Arborist Report

April 5th, 2023

Aspen Homes/Tubbs/Gudipaty
3632 90th Ave SE
Mercer Island, Wa

From COM Reviewers:

Tree 1660-*Acer palmatum*/Japanese Maple. DSH-13". DLR-13'. Tree Protection Zone-13'. Condition-6.

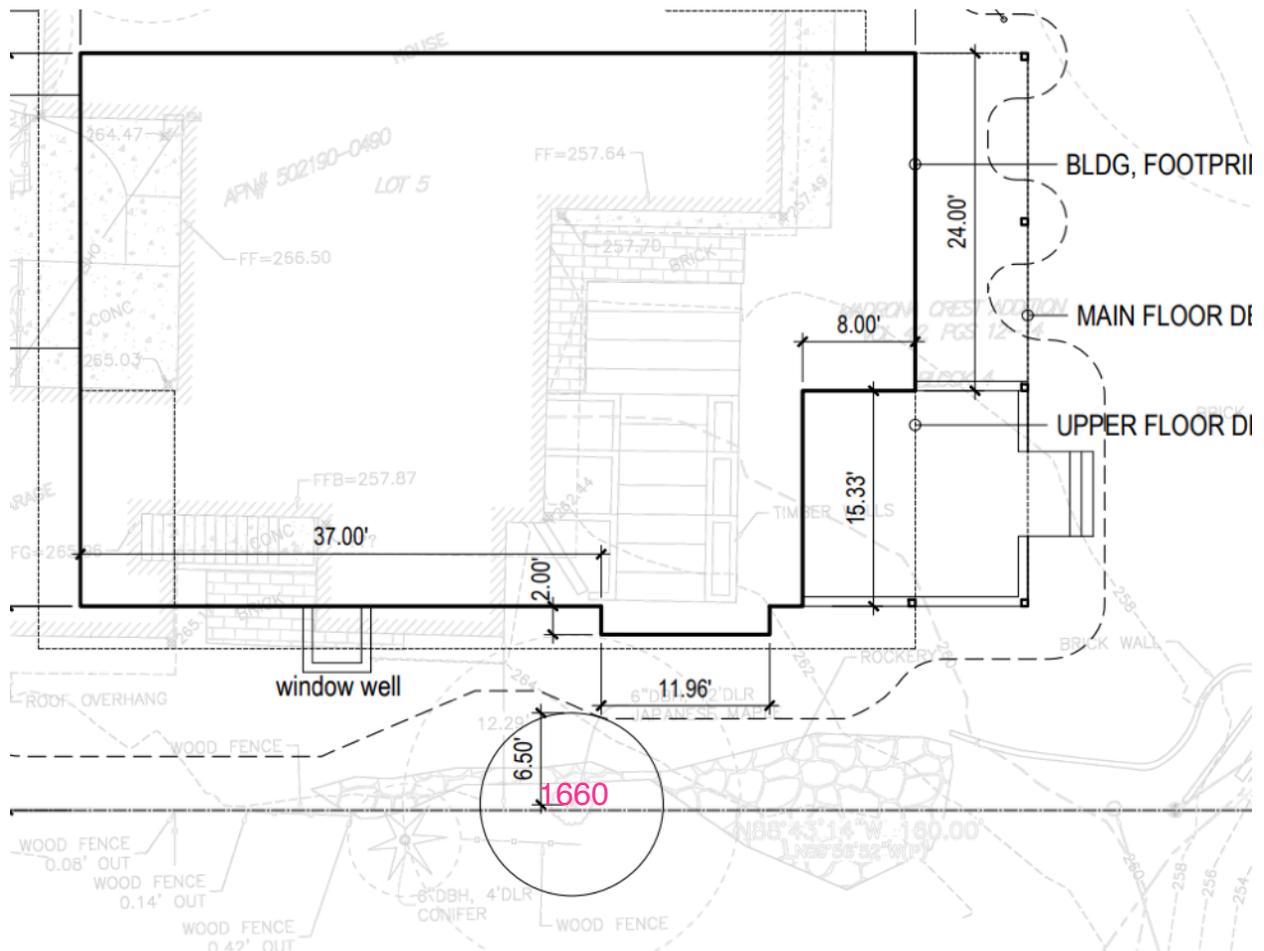
2. (From intake screening for arborist) Tree 1660 is exceptional in size. The arborist report does not indicate this or cite the correct tree code MICC19.10. The report must be updated with the correct standard for regulated and exceptional trees. Driplines or tree protection zones must be provided for all regulated trees. See checklist for all requirements.

Since discovering that this is an Exceptional Tree, that client has moved the proposed new building north to avoid the Tree Protection Zone. The Tree Protection Zone (congruent with the Critical Root Zone) is a circle with a 13' radius that has its centerpoint in the middle of the tree. Tree Protection Fencing should be installed at the tree's drip line prior to construction activities commencing and remain in place for the duration of the project. The TPZ should have 4" of mulch added to assist with water retention during the building process and to help build ideal, lasting soil conditions for the tree.

Revised Footprint Avoids Tree
